Certificate of Appropriateness

Property 3319 N. LAKE DR. North Lake Drive Estates Historic District

Description of work Phase 1 of the project at 3319 N. Lake Dr. was approved by the HPC on May 9, 2022. Phase 1 consisted of review of new garden wall, new garage, in-ground pool and pool house and landscaping.

Date issued 7/14/2022 PTS ID 115259 CC File # 220301

Proposed glass pool conservatory in two different views

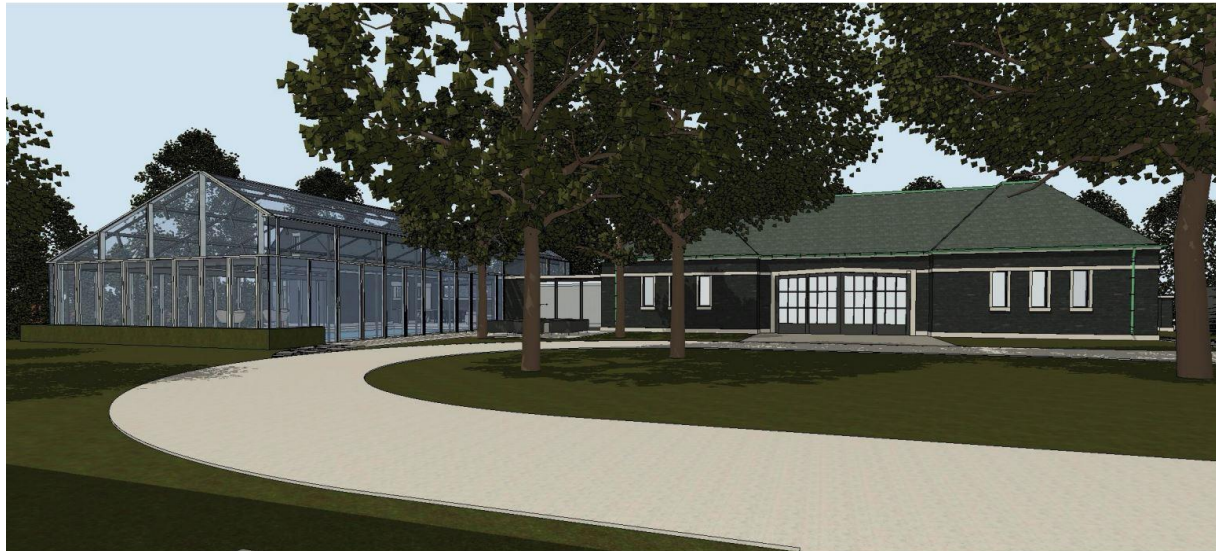
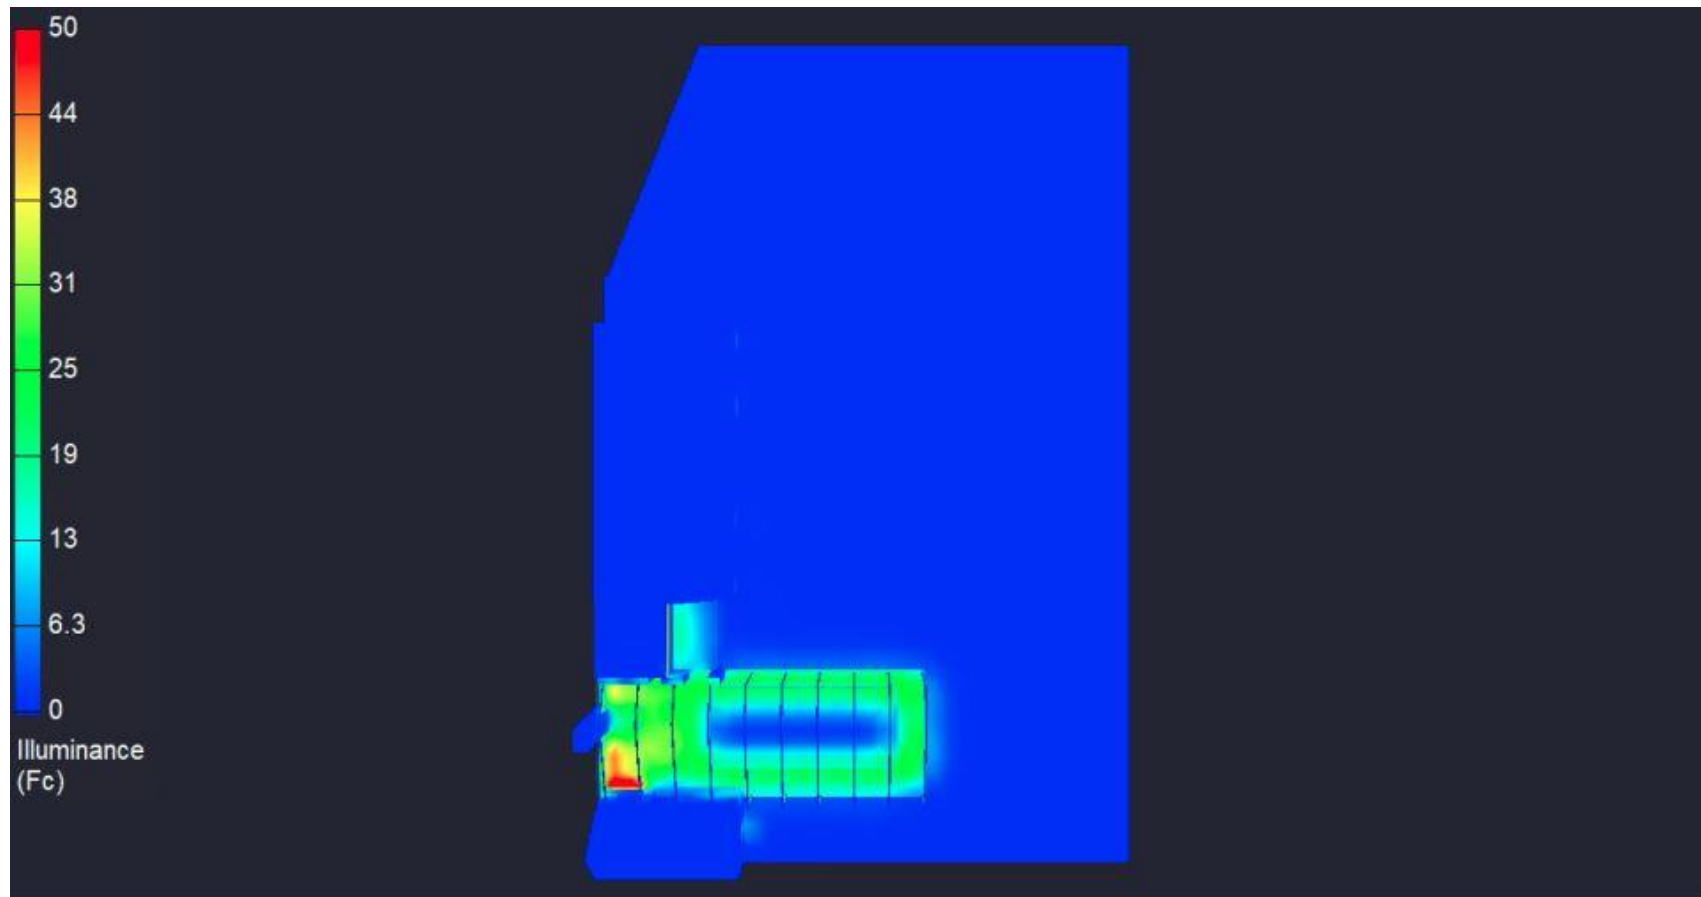
The all glass pool enclosure or pool conservatory will be constructed as designed with one longer slope (4-1/2 x 12 pitch) and one shorter slope (6-1/2 x 12 pitch). There is precedence for this in a horticultural greenhouse that once was part of the property. This type of treatment was also common in the early 20th century and can be seen in garden building catalogues of the period. The glass walls are designed to slide back and open the pool to the outside.

Lighting calculation showing light diminished at northwest corner of the property

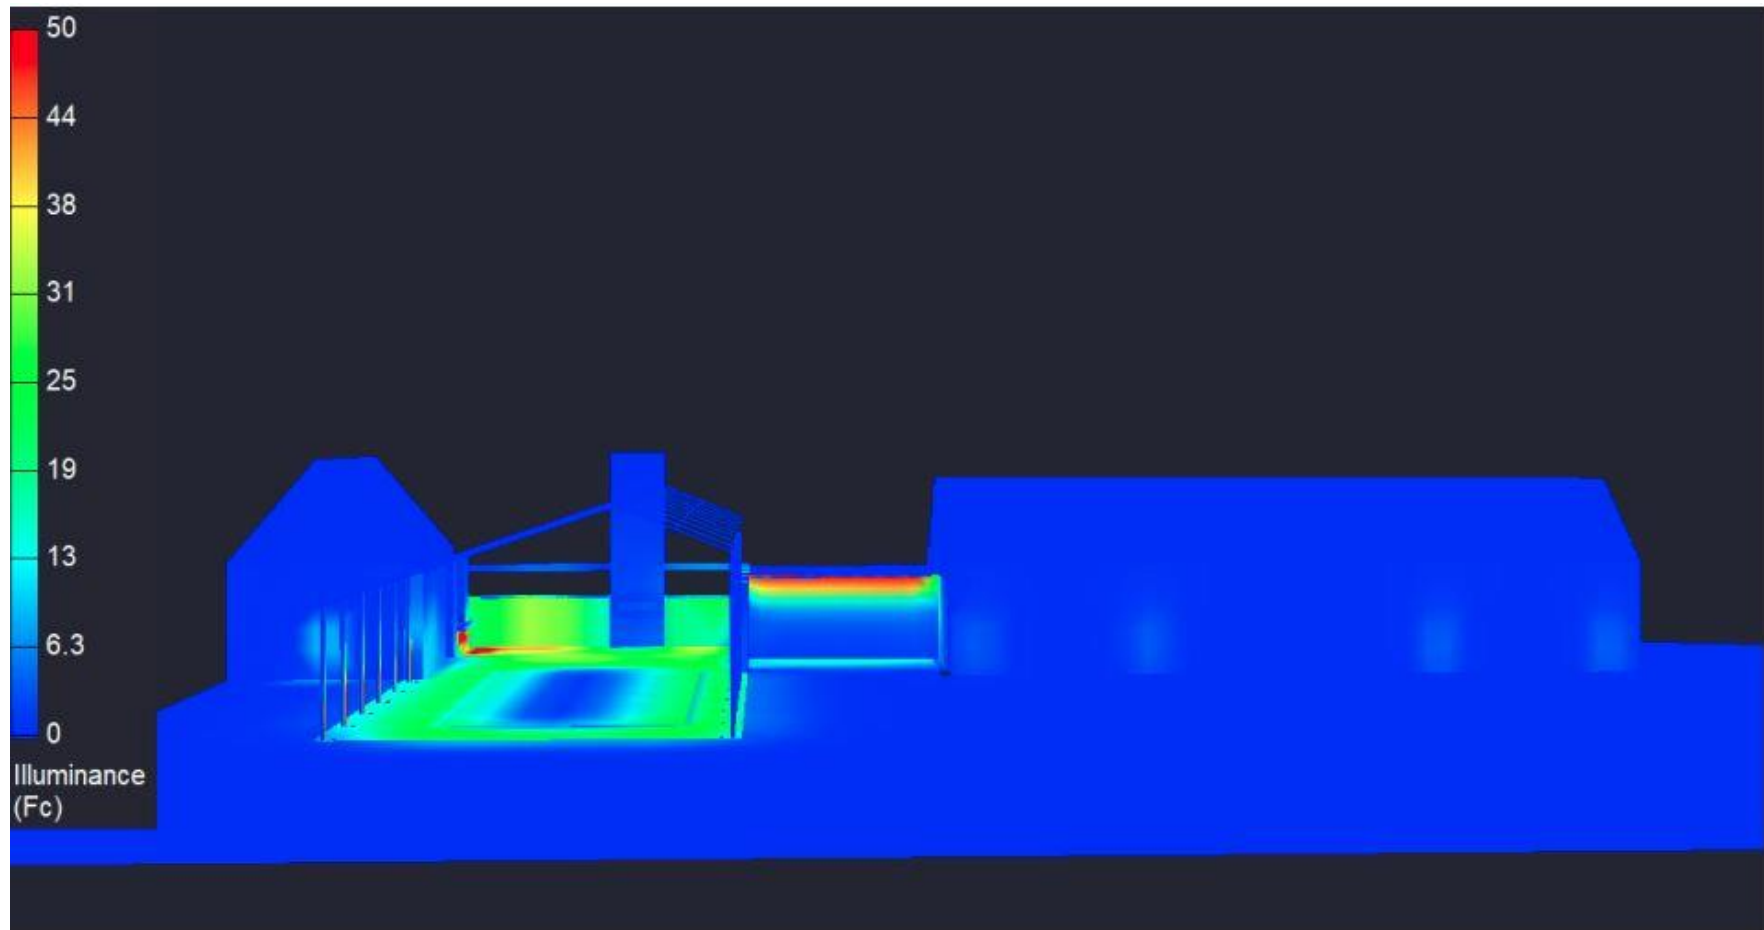
The lighting will involve a number of different fixtures which are set to illuminate the garage and pool and adjacent areas both on the interior and exterior. There will also be some landscape lighting close to the pool. Lighting calculations show that the maximum intensity will be concentrated at the pool but not spill over to the neighbors' properties.

Landscaping plan in color

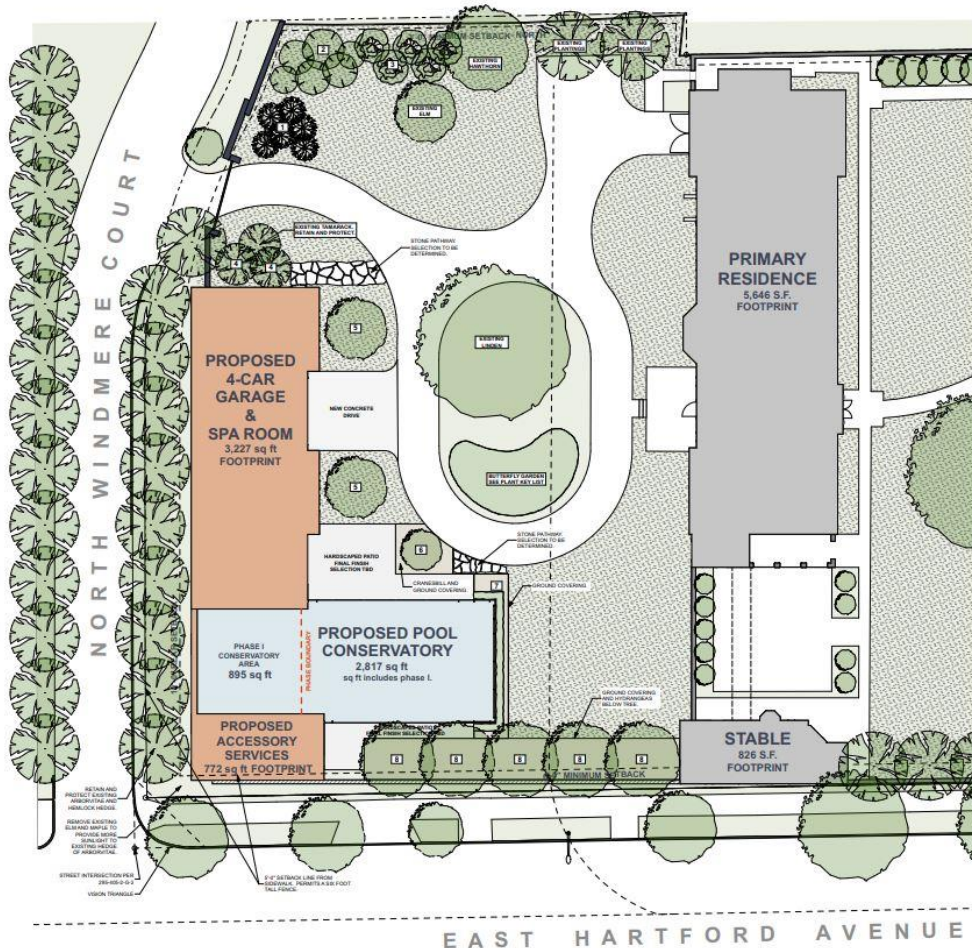
Additional landscaping, using serviceberry and 14-foot to 16-foot tall arborvitae, will screen the property at its northwest corner. There will also be trees along the perimeter of the property that will screen the pool enclosure from the public. A trimmed boxwood hedge will serve as a base of the glass pool enclosure at its east end and will remain green year round.
